ROUTE 9A - WEST STREET PROMENADE PROJECT  
 RECONSTRUCTION OF RT. 9A-WEST ST. (BATTERY PLACE TO CHAMBERS ST.)  
 MANHATTAN, NEW YORK COUNTY

FIELD CHANGE SHEETS (JUNE 6, 2012)

BATTERY PARK UNDERPASS APPROACH WALLS MODIFICATIONS

BATTERY PARK UNDERPASS APPROACH WALLS  
DETAILS & SECTIONS - 2

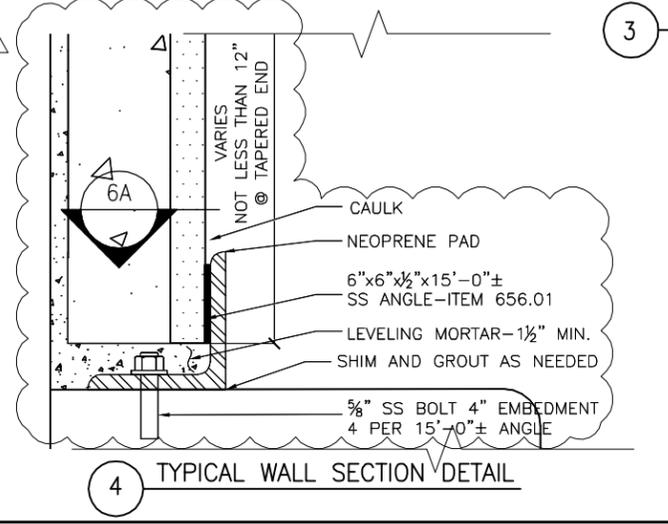
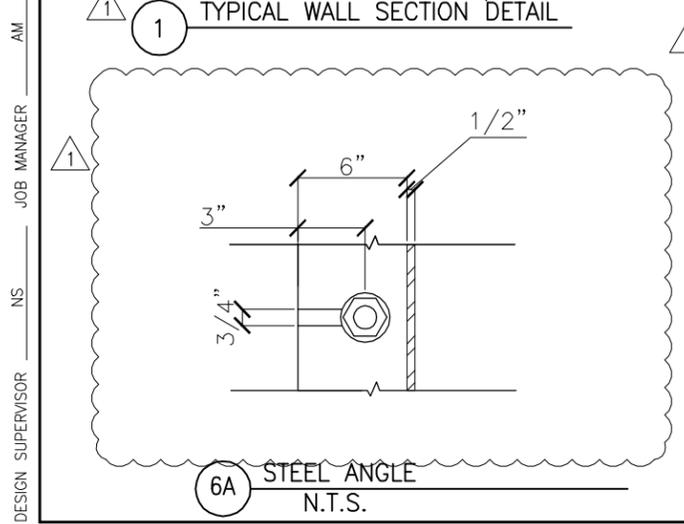
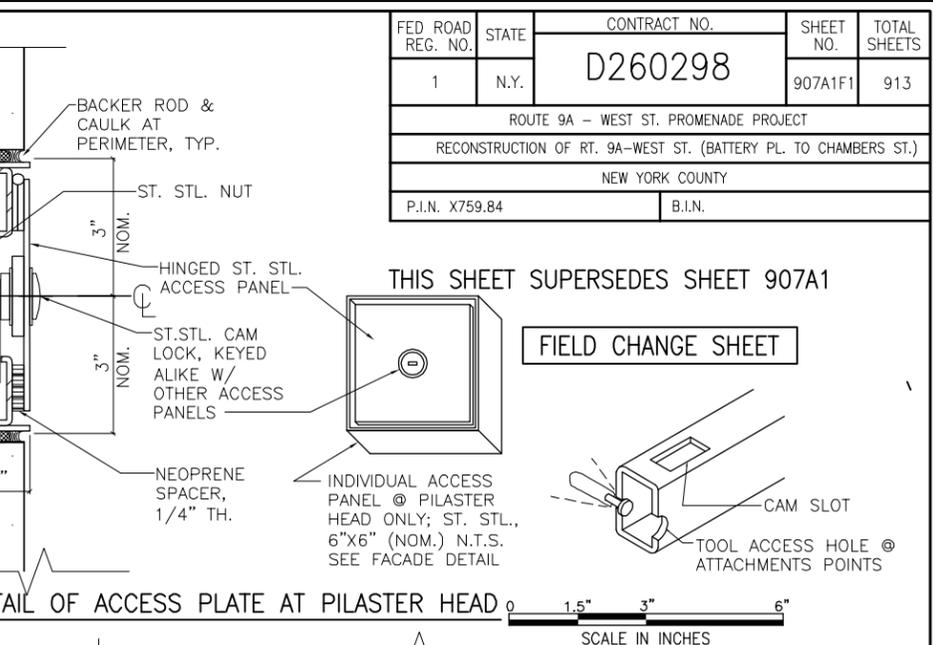
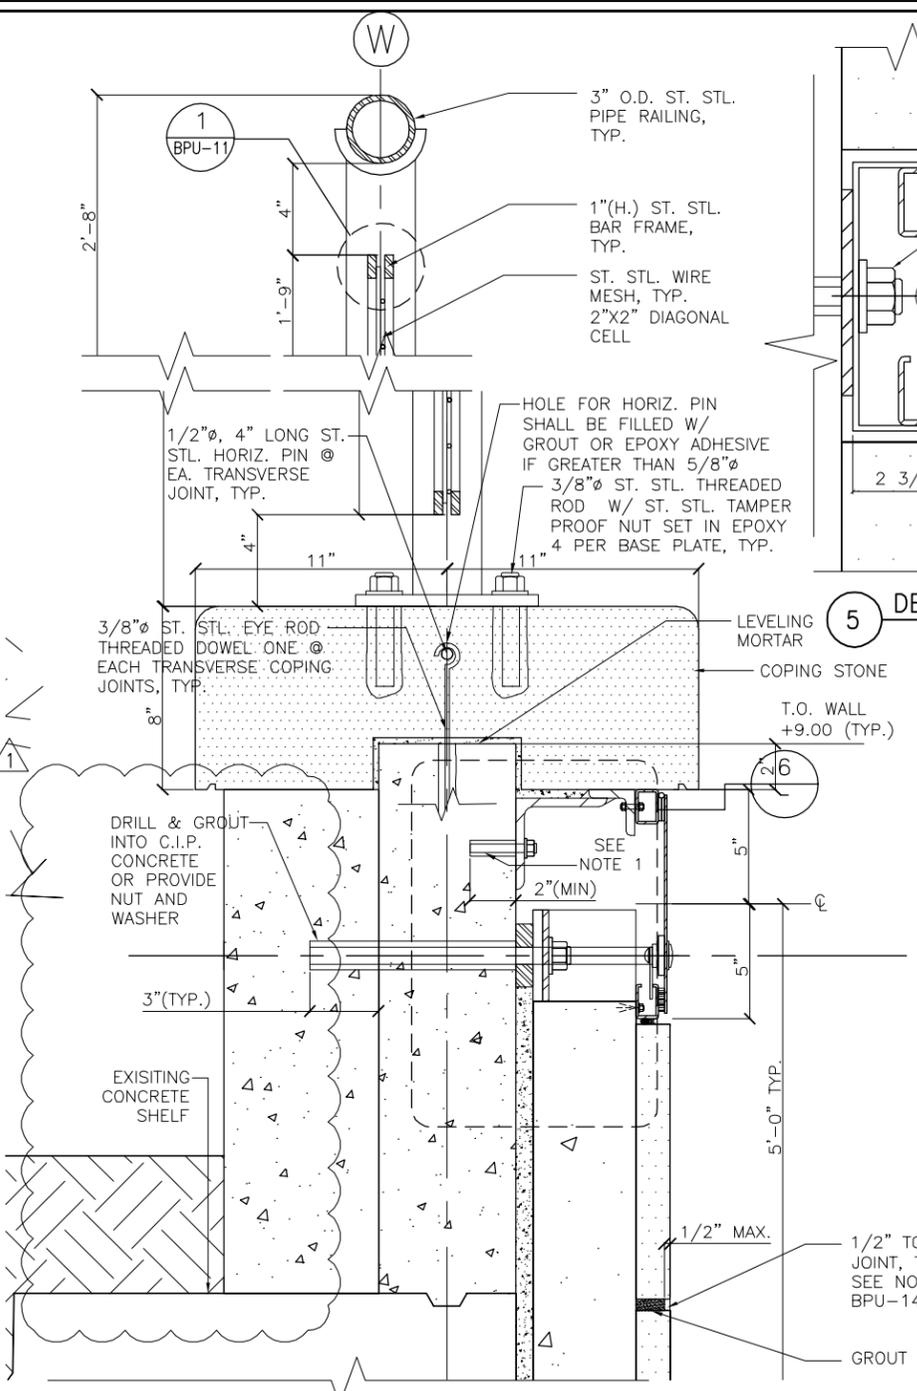
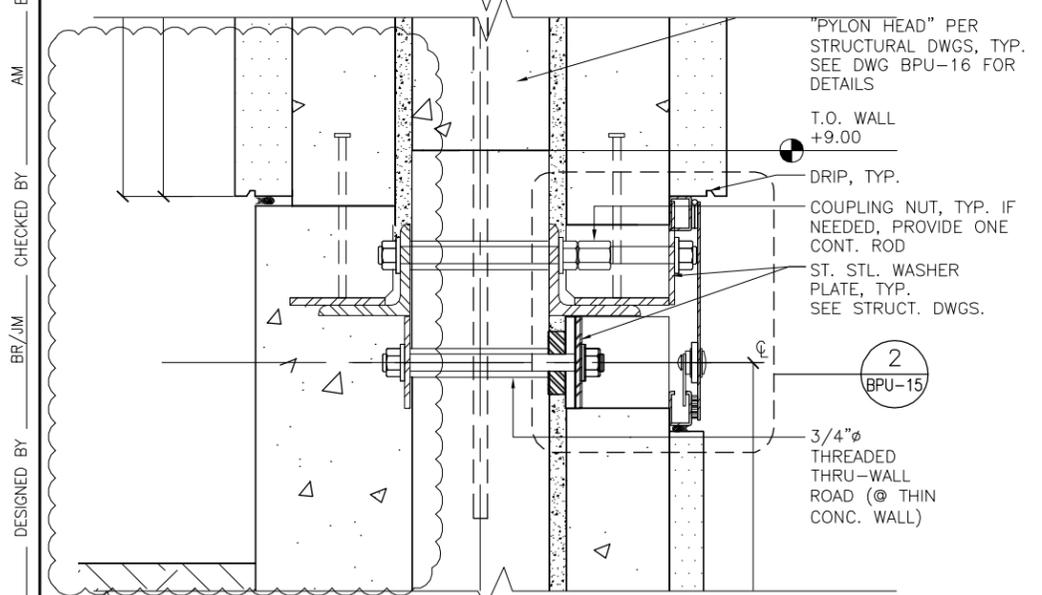
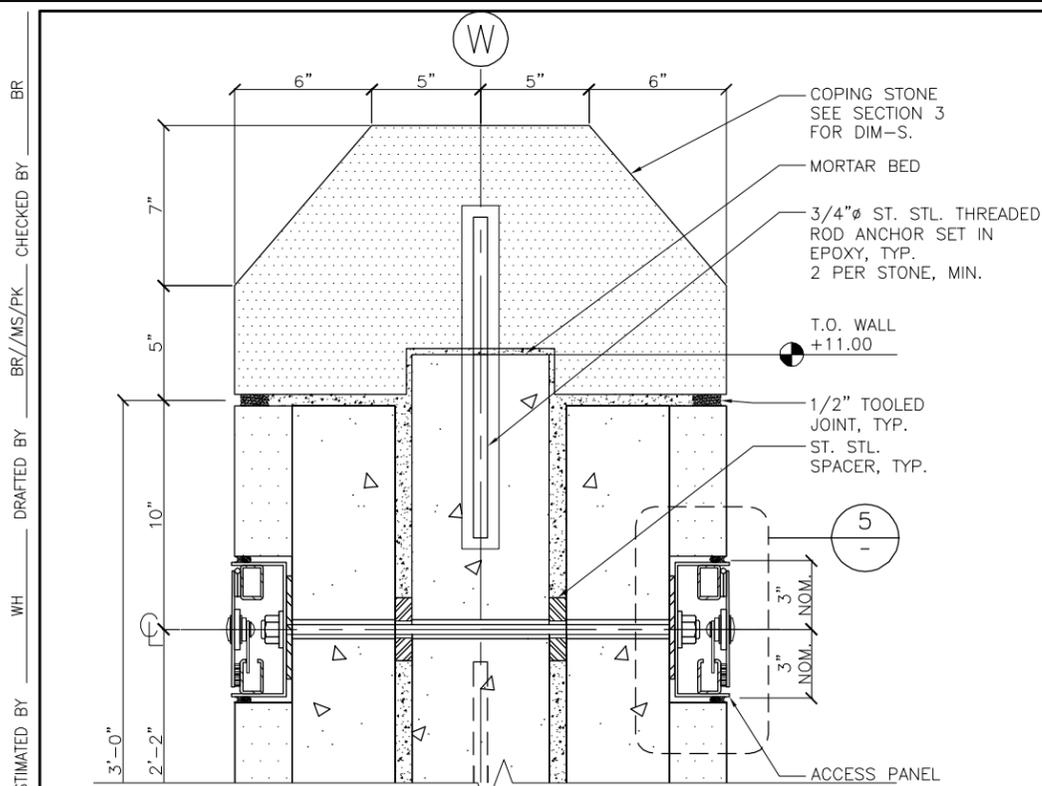
NO.	DESCRIPTIONS	DATE
1	CHANGED TO TYPICAL WALL SECTION DETAIL, ADDED DETAIL 6A	05/08/2012

- NOTES:
- PROVIDE 3 BOLTS PER 33" OR 36" ACCESS PANEL, 2 PER 18" ACCESS PANEL
  - FOR C.I.P. STONE, SEE DETAIL ON DWG. NO. BPU-16

STATE OF NEW YORK DEPARTMENT OF TRANSPORTATION			
FILENAME x01322bpu-11_plt	REGION 11	DATE 03/26/2012	DRAWING NO. BPU-11

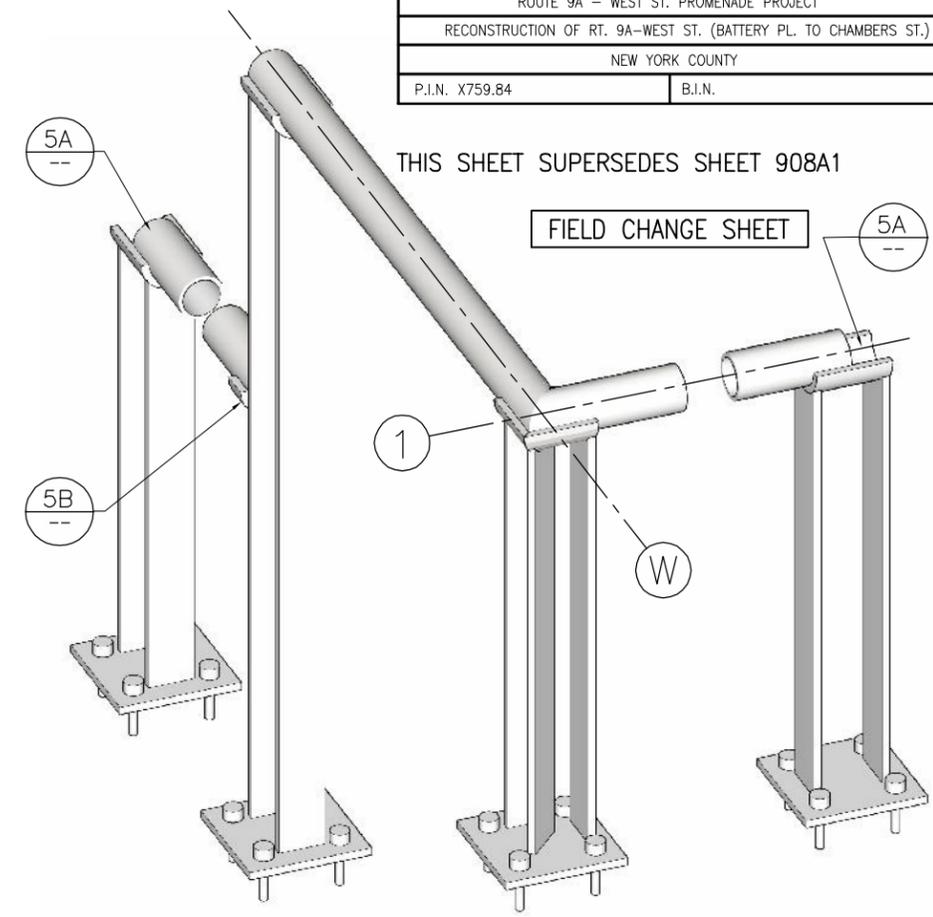
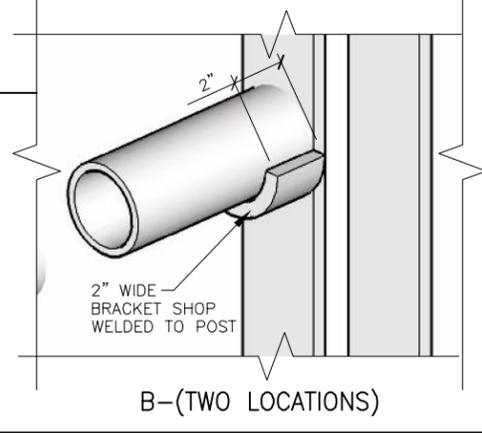
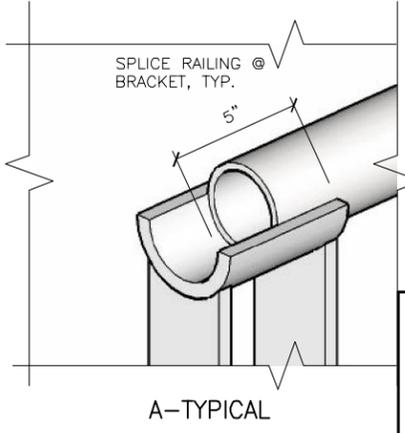
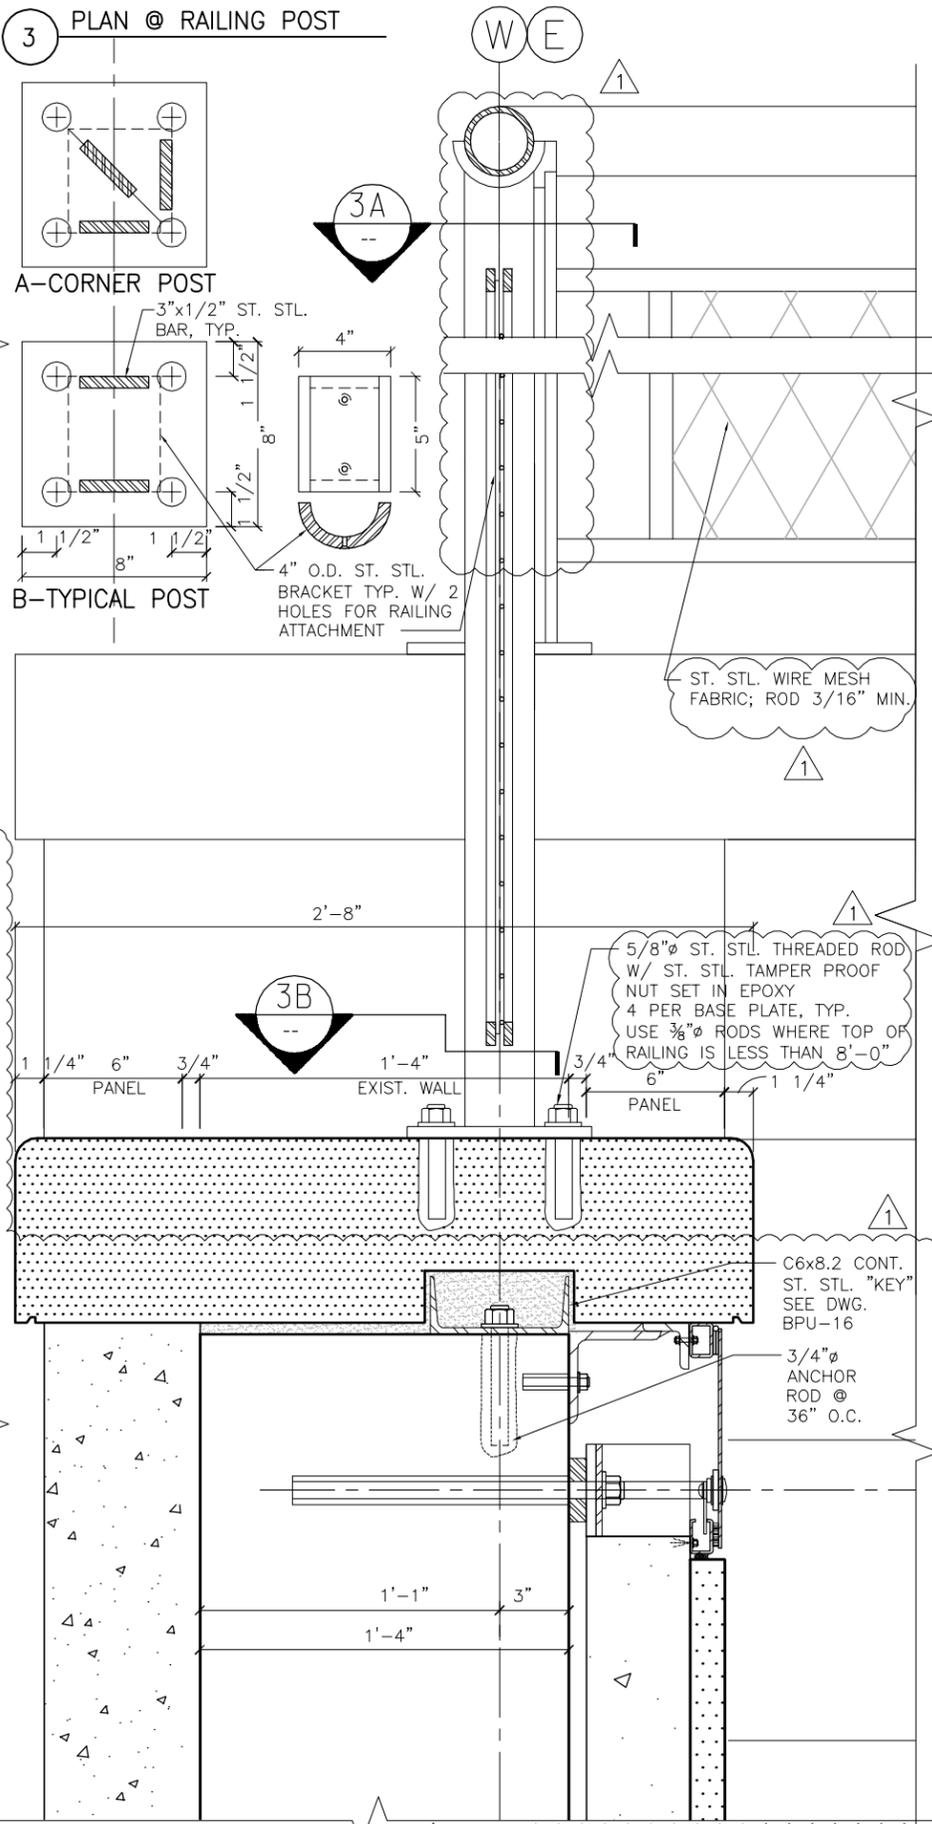
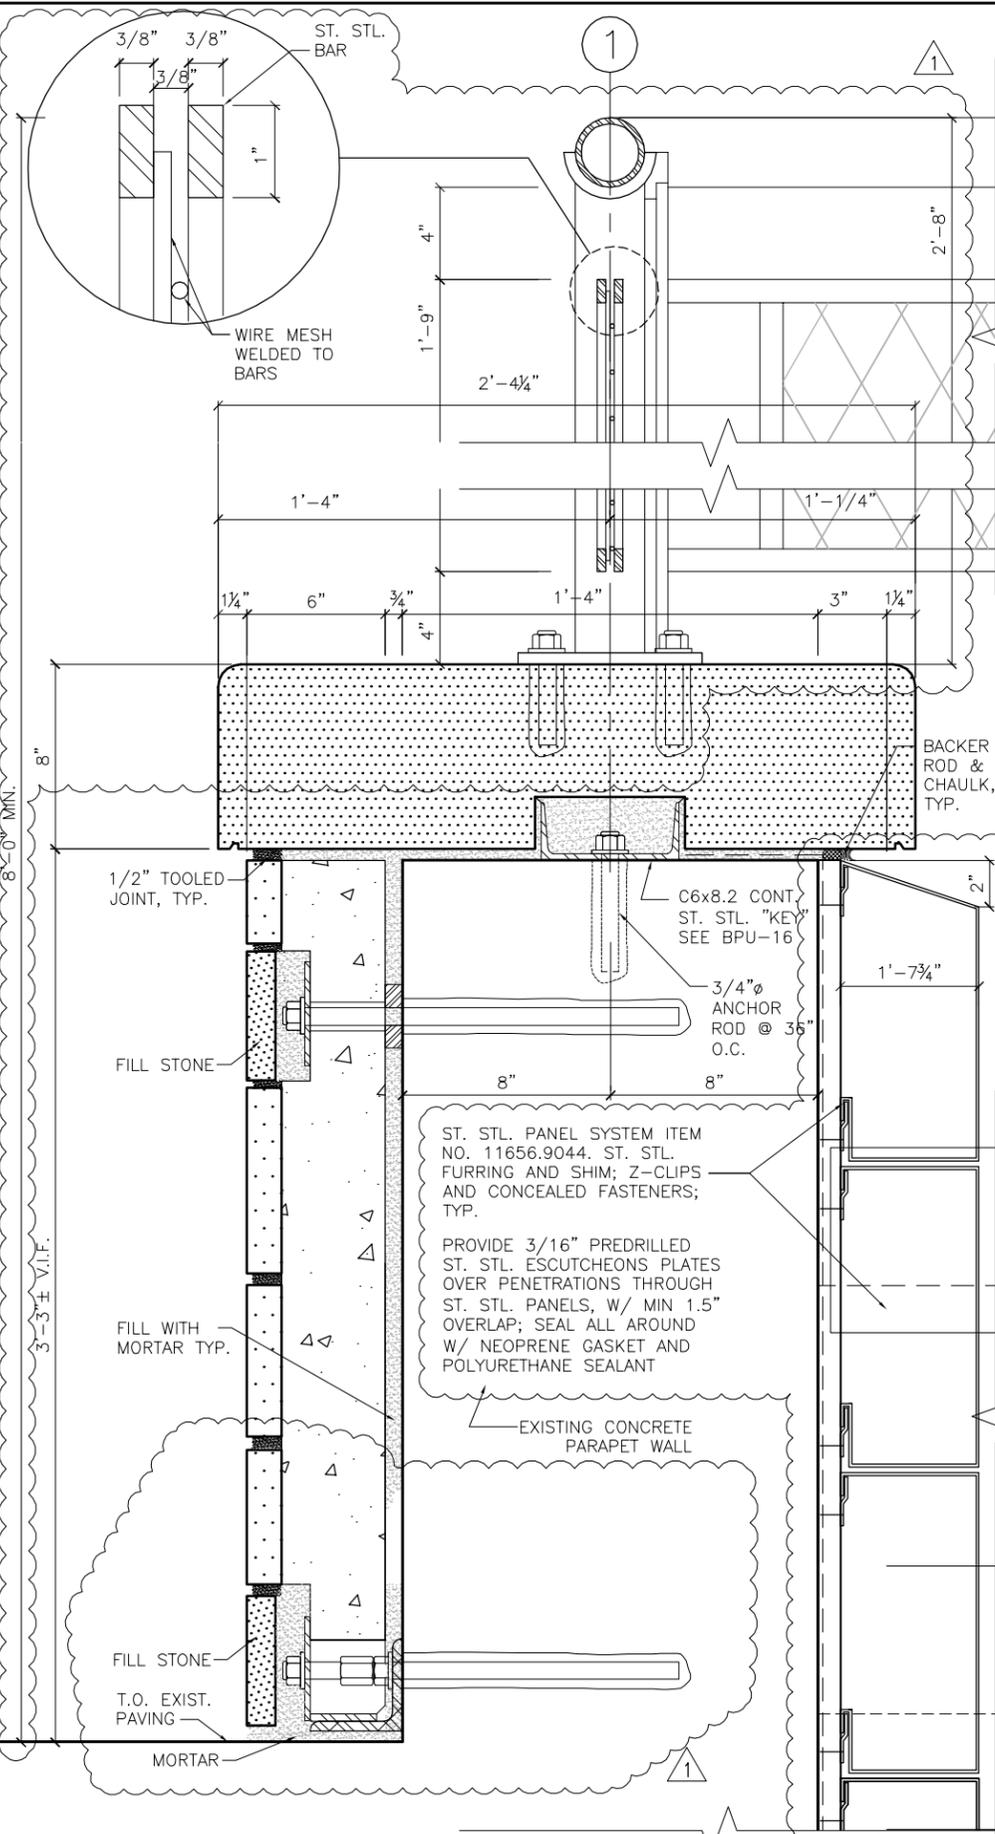
CHANGES IN TYPICAL DETAILS		
NO.	DESCRIPTIONS	DATE
1		05/08/2012

1 PANEL SYSTEM COMPONENTS "EXPLODED" AXON VIEW FROM ABOVE, N.T.S.

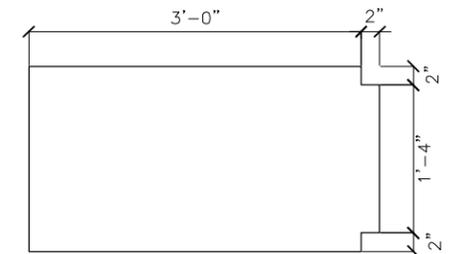
NO.	DESCRIPTIONS	DATE
1	DELETED PRECAST PANEL ON OUTSIDE AND PILASTER HEAD	05/08/2012
